Subject: Response to NRC Requests for Additional Information

Reference: Letter, Risk Assessment Branch RAIs, T. V. Wambach
(NRC) to E. H. Kennedy (C-E), dated October 30, 1991

RESPONSE TO NRC REQUESTS FOR ADDITIONAL INFORMATION
RISK ASSESSMENT BRANCH

P:BBU1BX

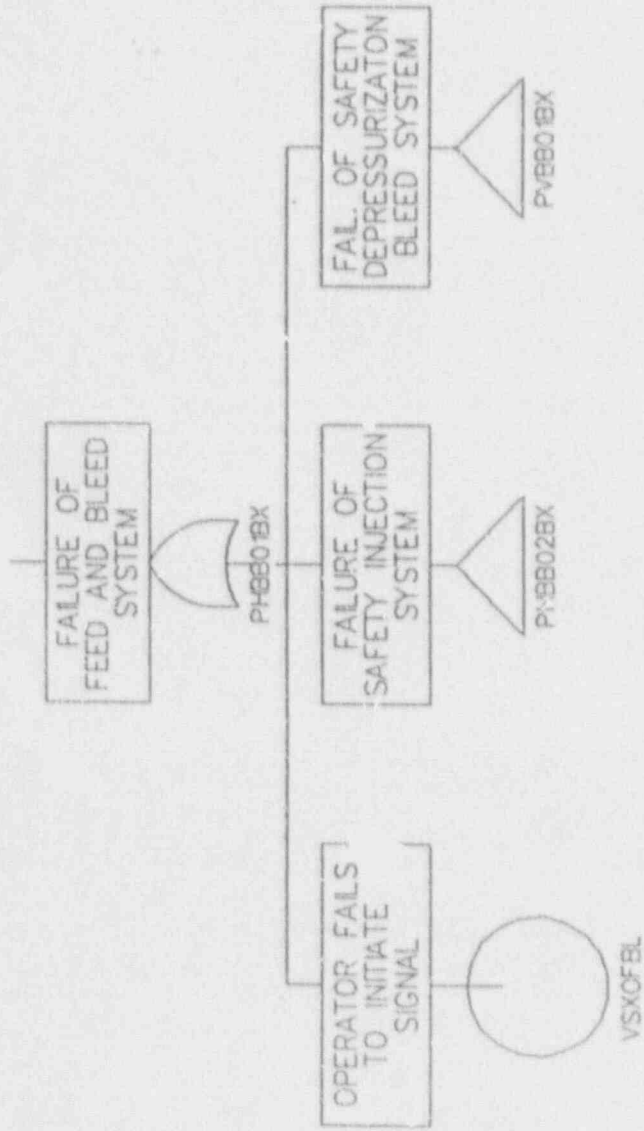
In the logical expressions of accident sequences #3 and #7 of a large secondary-side break event tree, as well as the event trees for the loss of feedwater and other transients (TOTH), should ~PHBB02BX (where ~X means logical "NOT X") be used instead of ~PHBB01BX?

The top event, PHBB01BX, is "Failure of the Feed and Bleed System". It includes both PHBB02BX (Failure of Safety Injection System) and PVBB01BX (Failure of the Safety Depressurization Bleed System). Thus, ~PHBB01BX is appropriate for the logical expressions for sequences #3 and #7 of the large secondary side Break, loss of feedwater and other transients (TOTH) event trees. The top event PHBB01BX was inadvertently left out of the System 80+ PRA Report (DCTR-RS-02, Rev 0). A copy of PHBB01BX is attached.

PHBB01DX

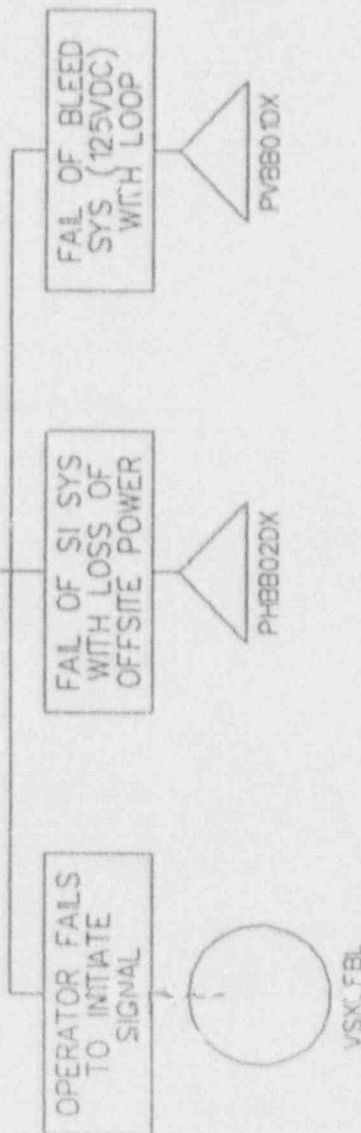
In the logical expressions of accident sequences #3, #4, #5, #7, #8, and #9 of the loss of offsite power event tree, should -SE-PSV (i.e., logical "NOT SE-PSV") be used instead of -PHSG01DX? Also, for accident sequences #3 and #7, should -PHBB02DX be used instead of -PHBB01DX?

In IRRAS 2.0, the complement logic is used only to delete failure terms that can not be true because of prior system successes. SE-PSV is a single element special event and is not included in any other model. Thus, including the complement of this element in the sequence definitions would not alter the result at all. The complement event, -PHSG01DX (logical "NOT (Failure to deliver safety injection to 4 of 4 loops with loss of offsite power)") should not be included in the logical expressions at all. Including -PHSG01DX in the sequences did not affect the sequence results because PHSG01DX is equivalent to PHBB02DX. The top event, PHBB01DX, is "Failure of the Feed and Bleed - Loss of Offsite Power". It includes both PHBB02DX (Failure to deliver sufficient safety injection flow to 4 of 4 loops with loss of offsite power) and PVBB01DX (Failure of Bleed System (125VDC) with loss of offsite power). Thus, -PHBB01DX is appropriate for the logical expressions for sequences #3 and #7 of the loss of offsite power event tree. The top event PHBB01DX was

inadvertently left out of the System 80+ PRA Report (DCTR-RS-02, Rev 0). A copy of PHBB01DX is attached.

PHBB01EX

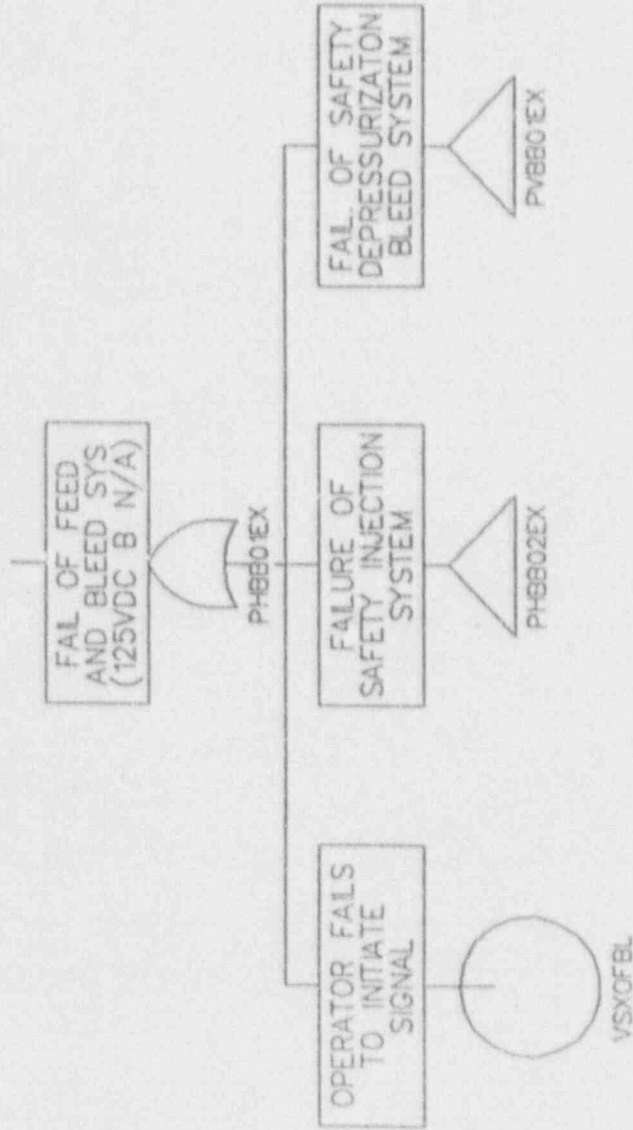
In the logical expressions of the accident sequences #3 and #7 of the loss of one 125V dc bus event tree, should -PHBB02EX be used instead of -PHBB01EX? Also, is there a missing term, -PVBB01EX in these expressions?

The top event, PHBB01EX, is "Failure of the Feed and Bleed System with 125V dc bus B not available". It includes both PHBB02EX (Failure of Safety Injection System with 125V dc bus unavailable) and PVBB01EX (Failure of the Safety Depressurization Bleed System (with one 125V dc bus unavailable)). Thus, -PHBB01EX is appropriate for the logical expressions for sequences #3 and #7 of the loss of one 125V dc bus event tree. The top event PHBB01EX was inadvertently left out of the System 80+ PRA Report (DCTR-RS-02, Rev 0). A copy of PHBB01EX is attached.

Figure 19

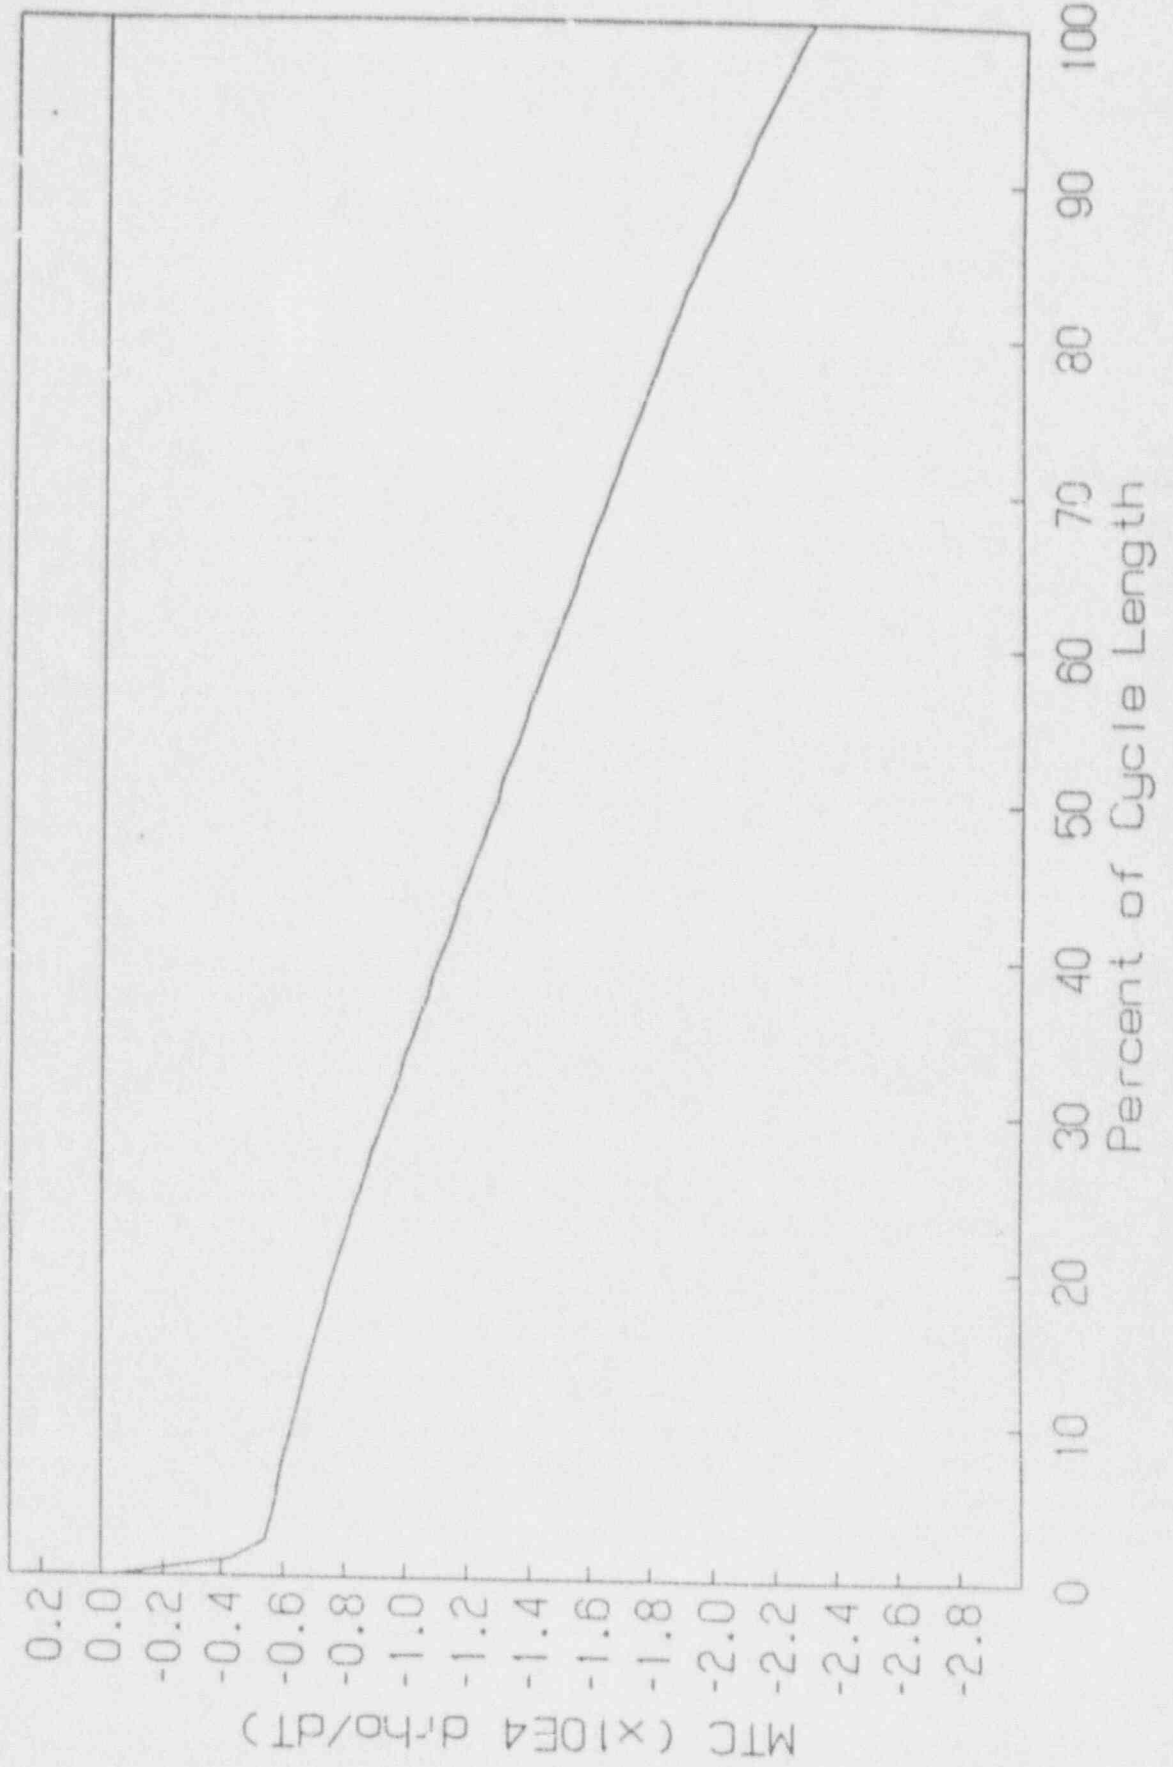
Based on CF calculations, the most dominant contributor to the core damage frequency attributable to ATWS is the sequence involving an ATWS followed by an adverse moderator temperature coefficient (MTC). Please explain how you calculated the probability of having an adverse MTC given an ATWS.

More clearly stated, ATWS sequence #26 is an ATWS that occurs while the MTC is adverse. The peak RCS pressure that is reached during an ATWS is partly a function of the MTC. The less negative the MTC, the higher the peak RCS pressure. The primary concern with an ATWS is the peak RCS pressure will be such that the RCS pressure boundary will be breached and the injection system check valves will be backseated such that there is an unmitigated LOCA. In SECY-83-293, it was stated that this should be assumed to occur if the peak RCS pressure exceeded the ASME level C stress limit pressure. Secy-83-293 used a value of 3200 psia for the level C stress limit. For this analysis, a set of thermo-hydraulic transient analysis runs were made, varying the MTC to determine the largest (least negative) value of MTC for which the RCS peak pressure would not exceed the level C stress limit pressure. (3200 psia was used as the level C stress limit pressure for the analysis.) The transient that was used for these analyses was a loss of main feedwater without turbine trip. MTCs more positive than the critical MTC thus determined were deemed adverse MTCs while MTCs more negative than this were deemed to be not adverse. A curve showing MTC versus core burnup (life) for an equilibrium System 80+ core was used to determine for what fraction of core life the MTC would be adverse. A copy of the MTC vs core burnup is attached. The response to RAI 440.11 provides the final revised ATWS analyses, but the conclusions are not changed.
